PLAN OF PROPOSED IMPROVEMENT

2901 UNIVERSITY AVE
THE QUARRY

CITY PROJECT NO. 11913
CITY CONTRACT NO. 8147

UTILITY PLAN AND PROFILE

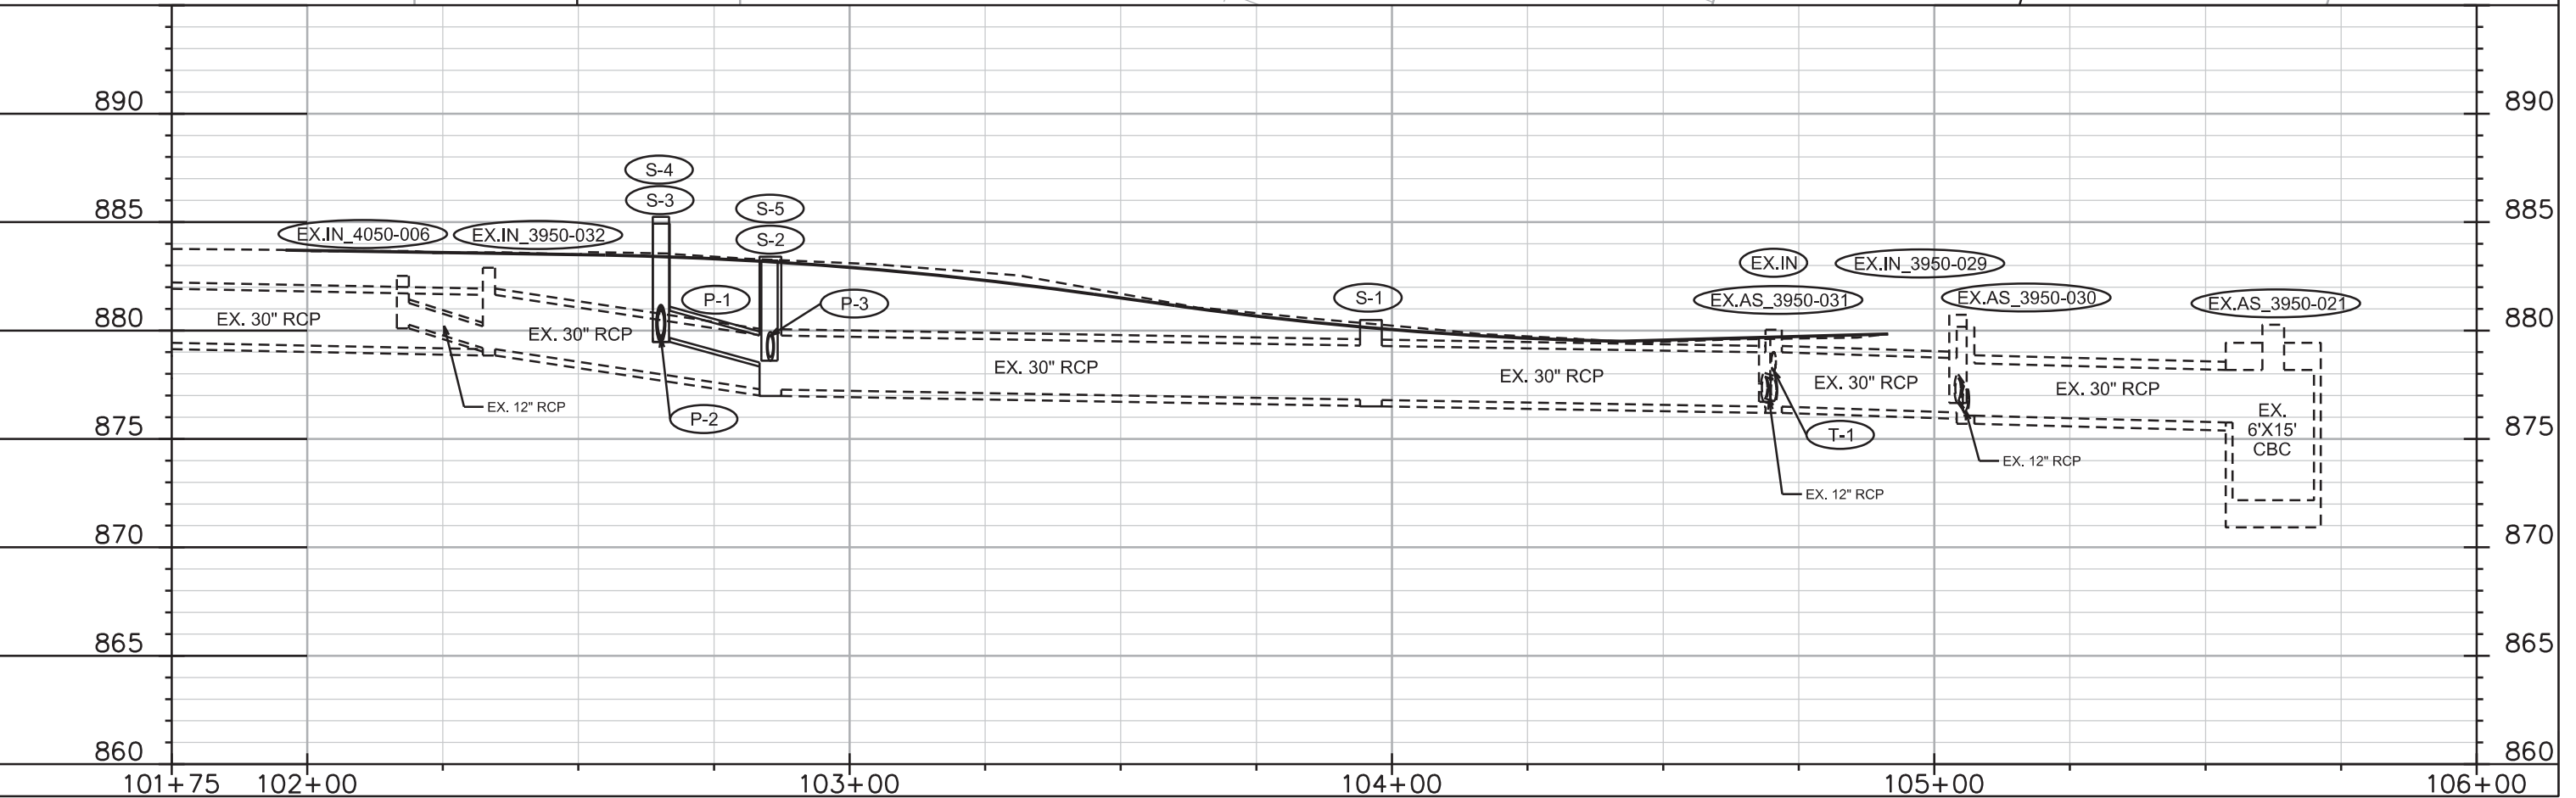
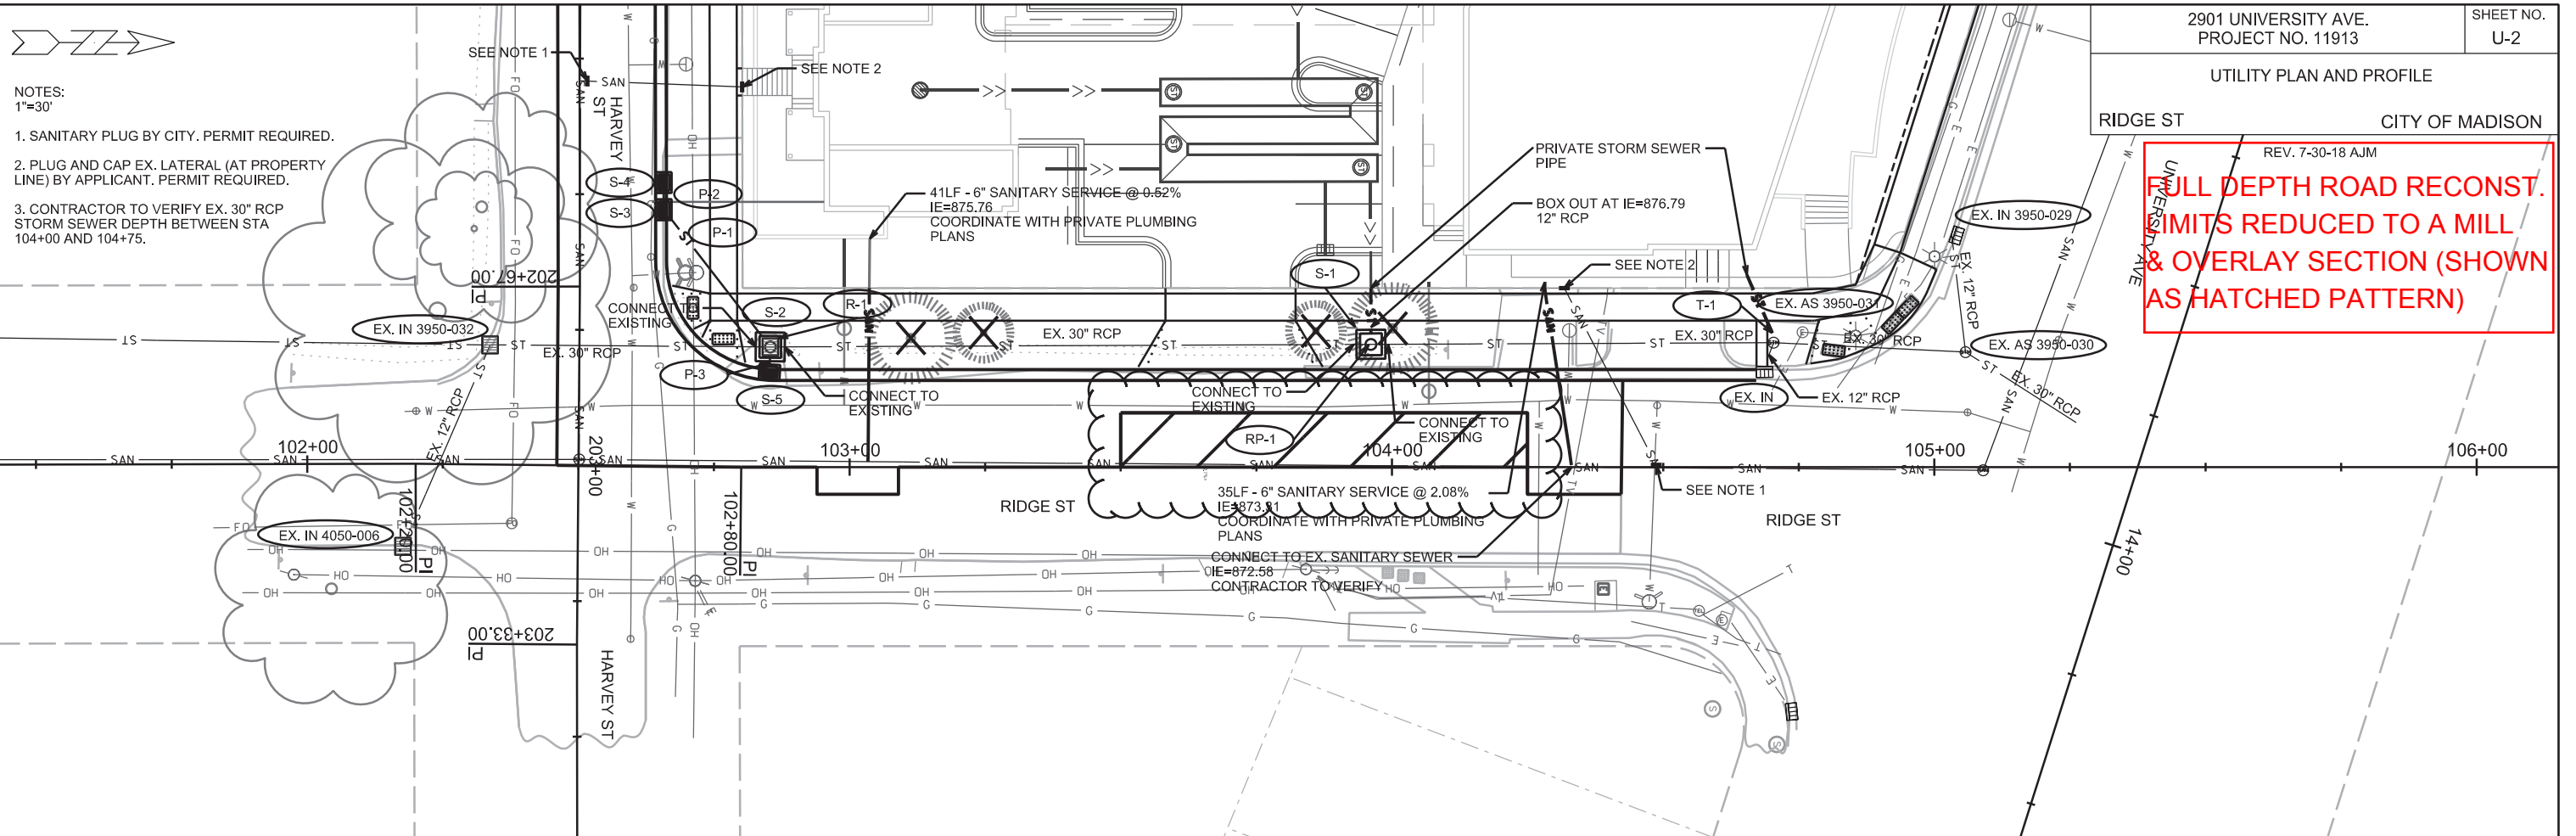
**FULL DEPTH ROAD RECONST.
LIMITS REDUCED TO A MILL
& OVERLAY SECTION (SHOWN
AS HATCHED PATTERN)**

CROSS SECTIONS

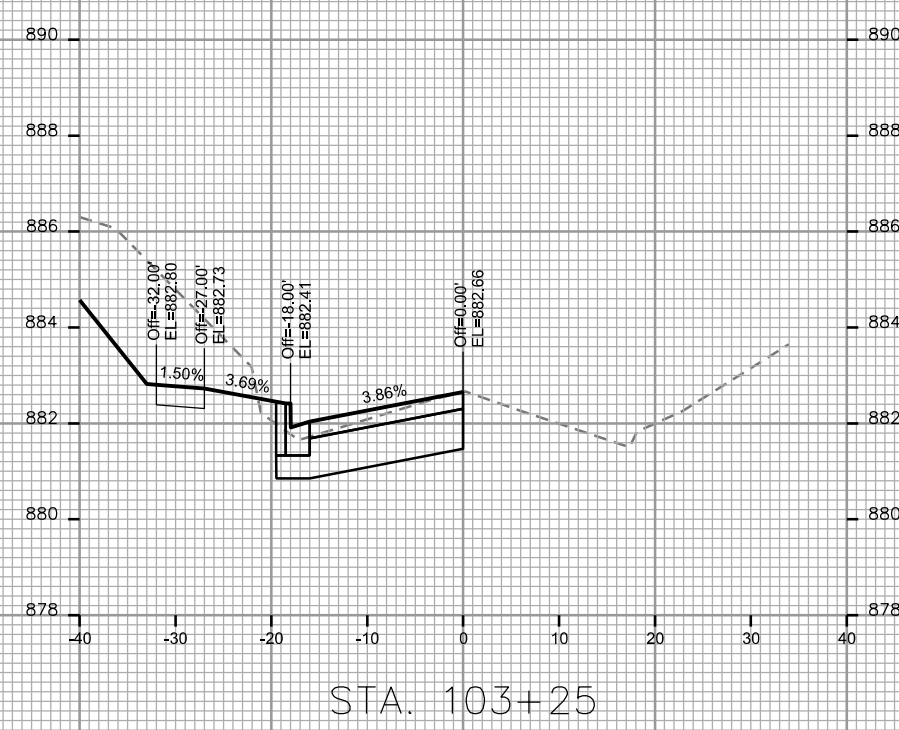
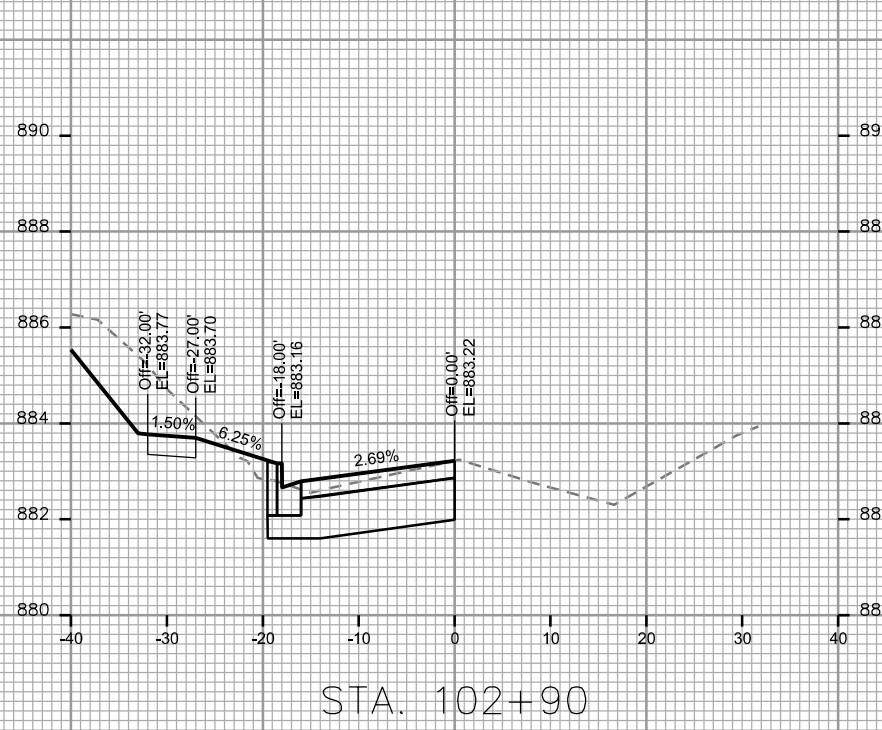
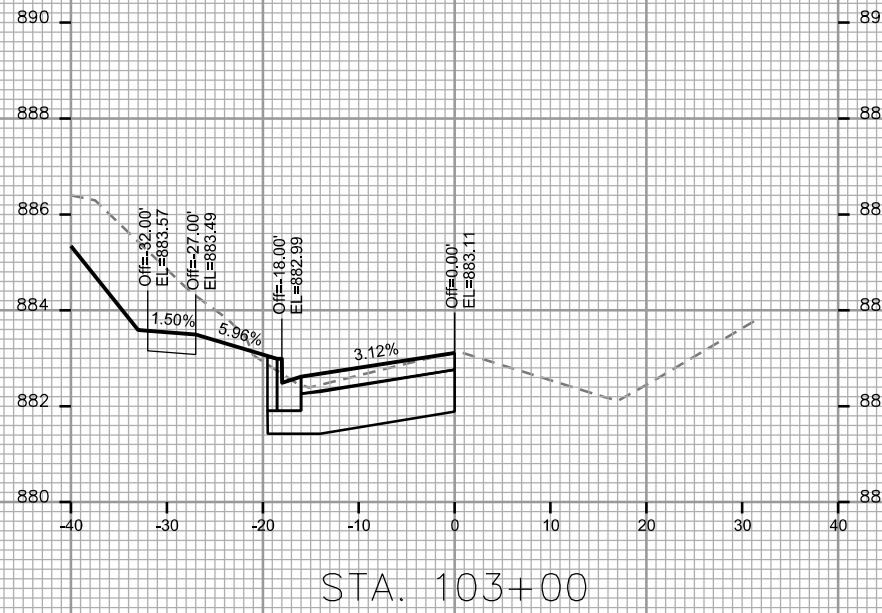
REV. 07-30-18 AJM
FULL DEPTH ROAD RECONST.
LIMITS REDUCED TO A MILL
& OVERLAY SECTION (SEE P-2 & D-2
FOR DETAILS)

CROSS SECTIONS

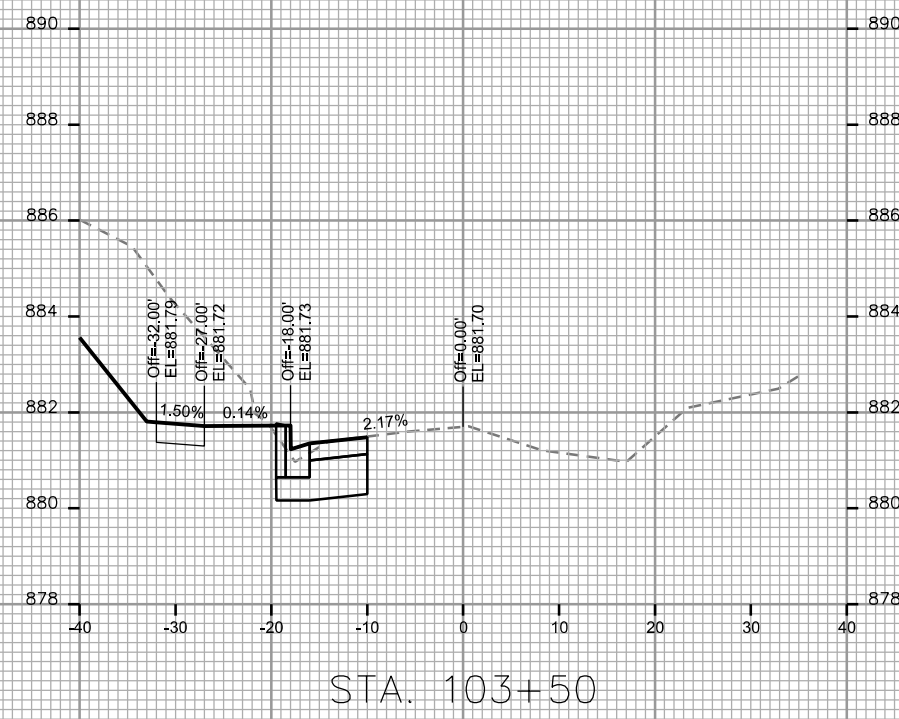
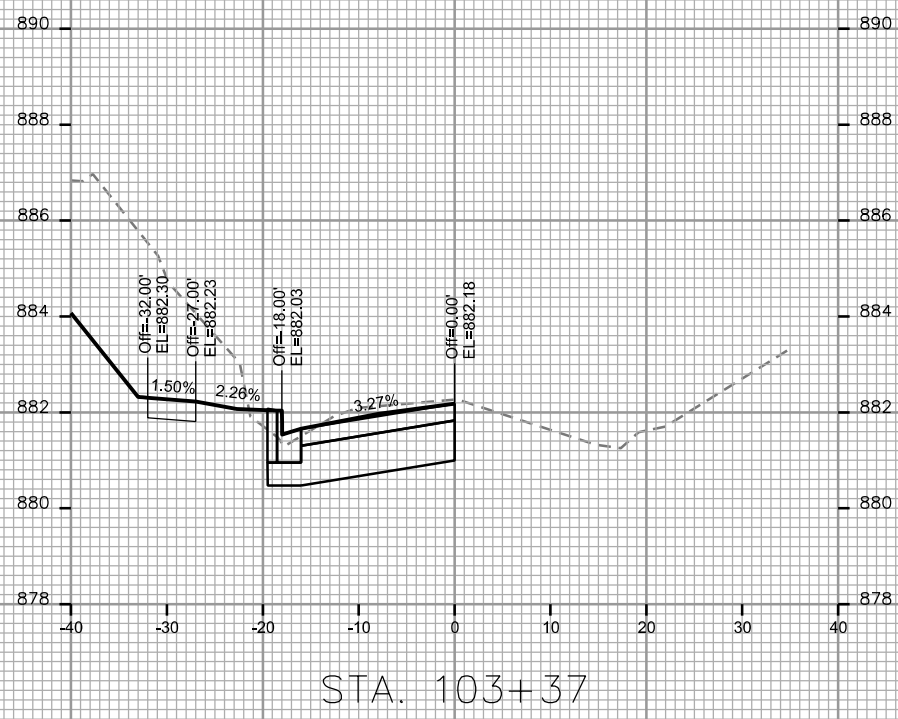
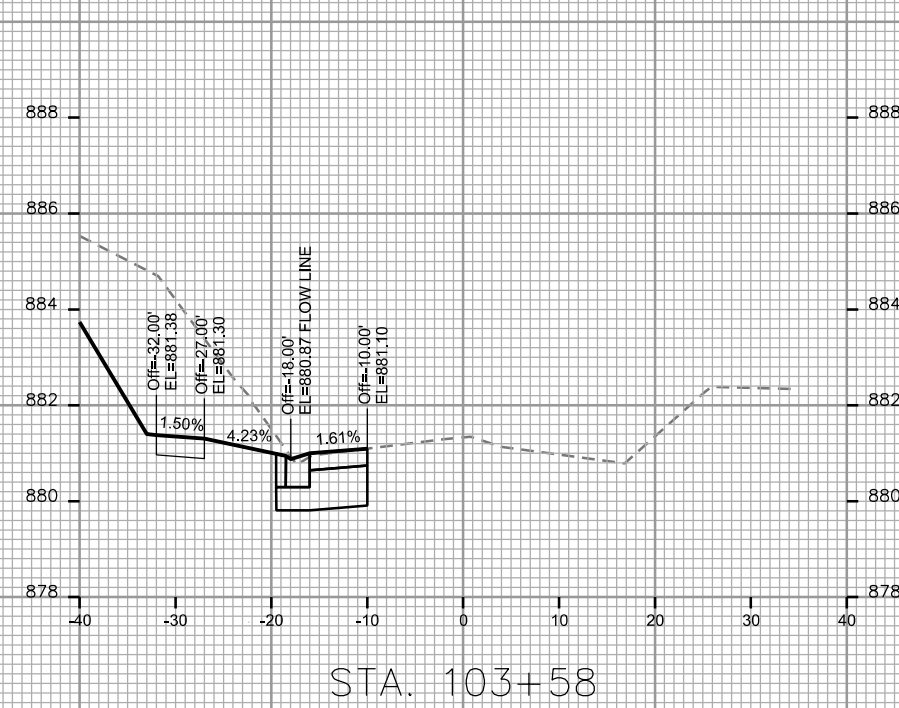
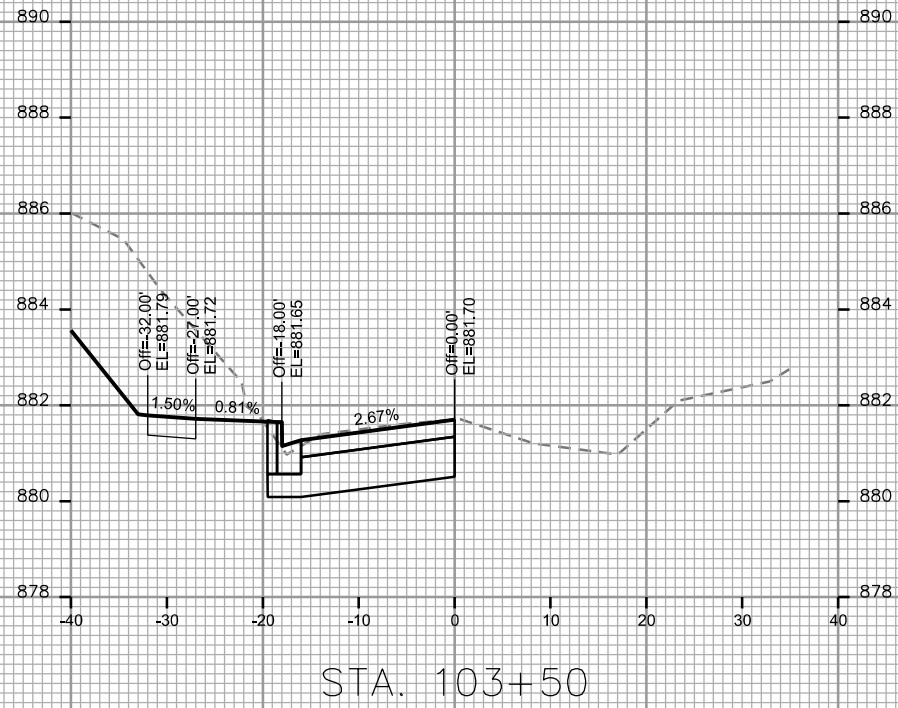
REV. 07-30-18 AJM
FULL DEPTH ROAD RECONST.
LIMITS REDUCED TO A MILL
& OVERLAY SECTION (SEE P-2 & D-2
FOR DETAILS)

CROSS SECTIONS

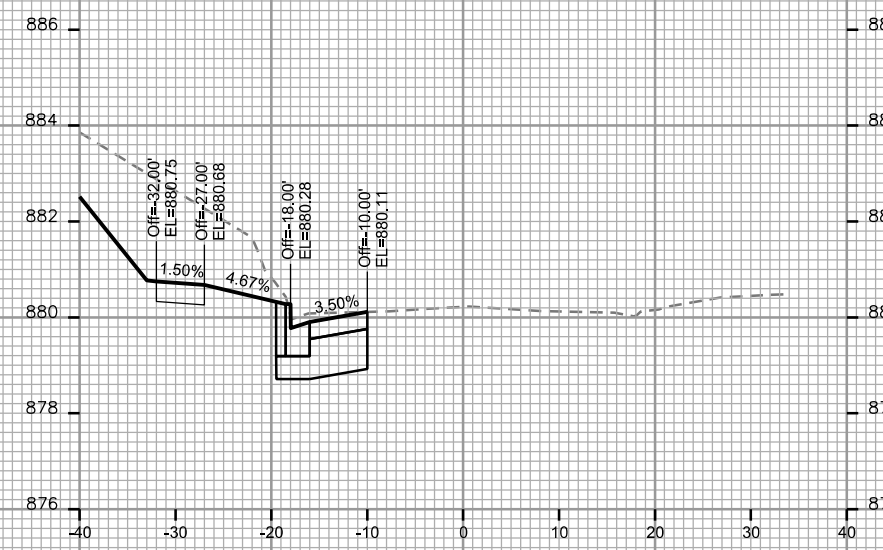
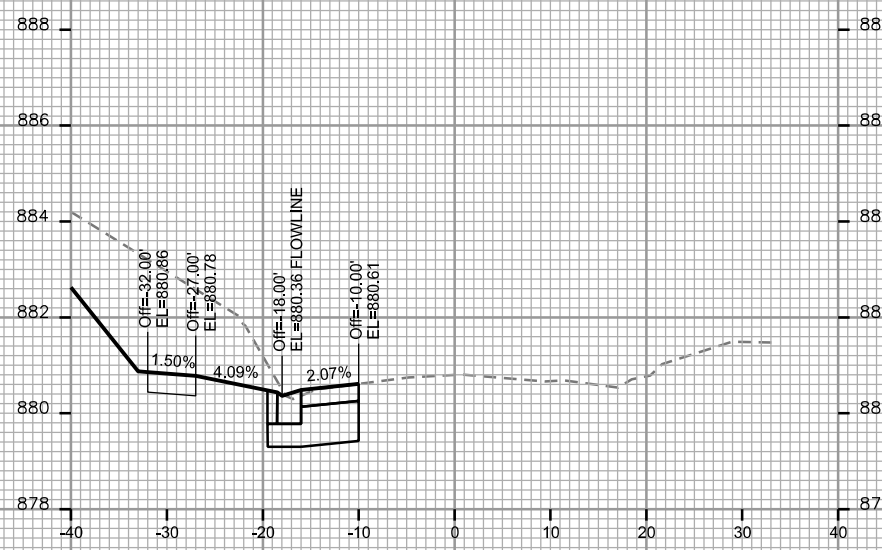
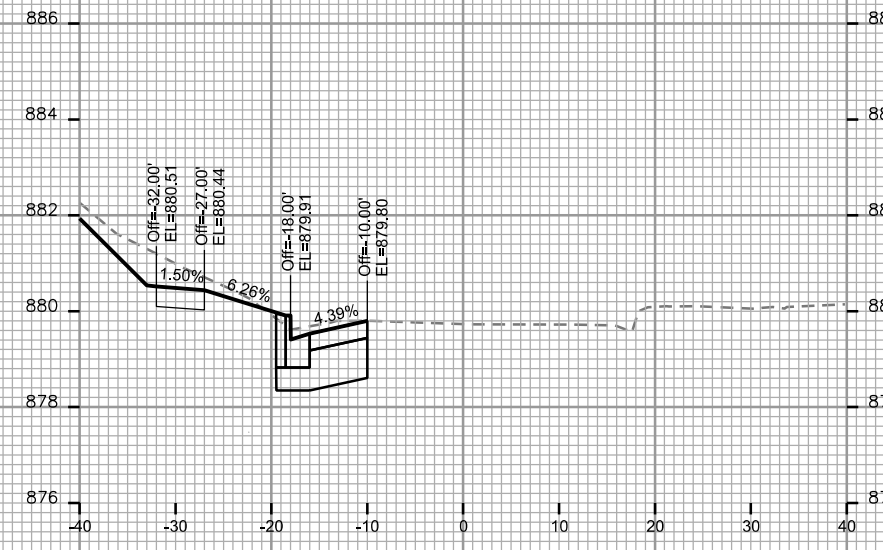
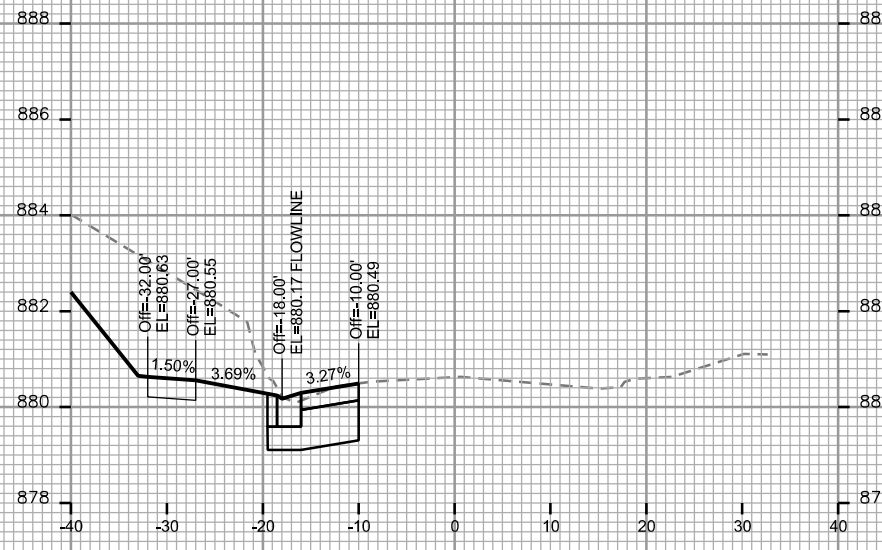
REV. 07-30-18 AJM
FULL DEPTH ROAD RECONST.
LIMITS REDUCED TO A MILL
& OVERLAY SECTION (SEE P-2 & D-2
FOR DETAILS)

CROSS SECTIONS

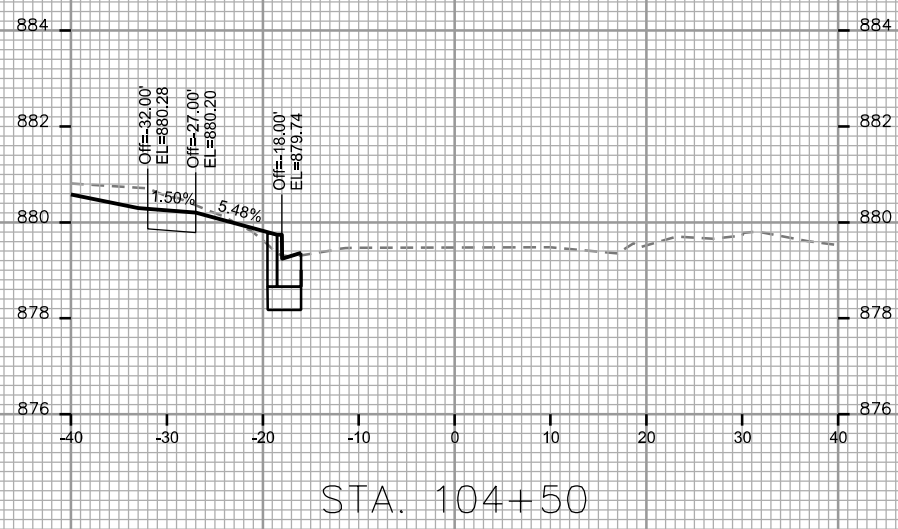
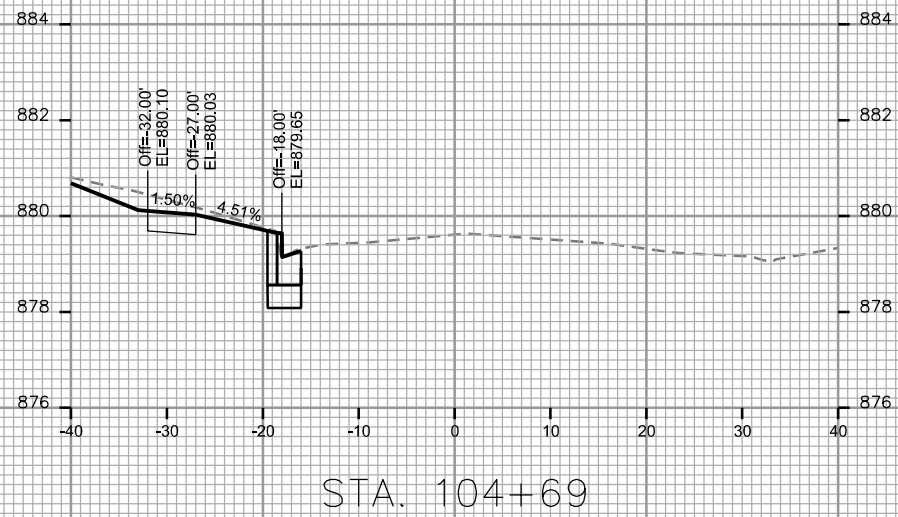
REV. 07-30-18 AJM
FULL DEPTH ROAD RECONST.
LIMITS REDUCED TO A MILL
& OVERLAY SECTION (SEE P-2 & D-2
FOR DETAILS)
